ICOMOS Reactive Monitoring Mission to the World Heritage property

"Historic Centre of Vienna" (Austria) (C1033)

Mission Report

- 3D visualisation showing the impact of the proposed Intercontinental Hotel buildings on the aerial view of the Vienna Historic Centre from the North-East

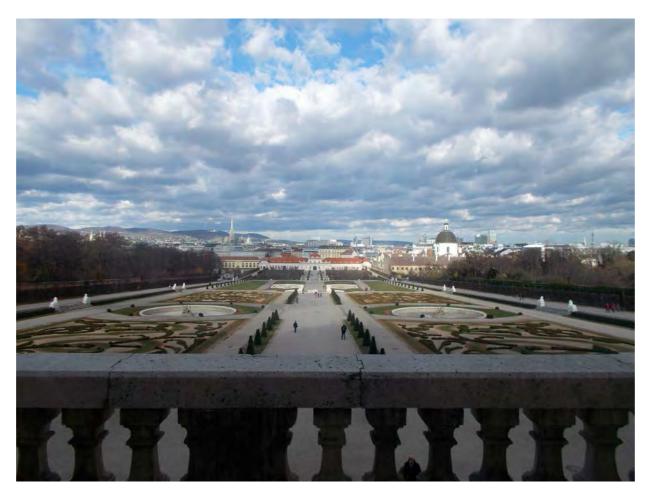
The 3D visualisation models show how the volumes designed by the winning project would strongly exert a negative impact on the cityscape, occupying conspicuously the axial part of the panorama that currently can be enjoyed from the Belvedere Garden and how it would weaken the symbolic significance of the St. Stephen cathedral tower and of the other historic landmarks of the panorama. (See pictures and 3D visualisations n°3-4-5-6-7 in Annex V).

Notwithstanding the explanations regarding the approach and process for the architectural competition, the recently presented "winner solution" remains unacceptable: erecting a 70m high building to replace the existing 45m high one, and explaining that it will be less harmful to the silhouette in vistas from the World Heritage property (Belvedere Palaces) contravenes the recommendations made by the reactive monitoring mission that were endorsed by the World Heritage Committee at its 37th session (Phnom Penh, 2013).

ICOMOS therefore strongly urges the relevant State Party's authorities to facilitate major revision to the project proposal so to reduce the height, as recommended by the 2012 reactive monitoring mission, and to take into account scale and massing in the revised proposal in relation to the characteristics of the specific location., as well as to the specific attributes that convey the Outstanding Universal Value of the property in order:
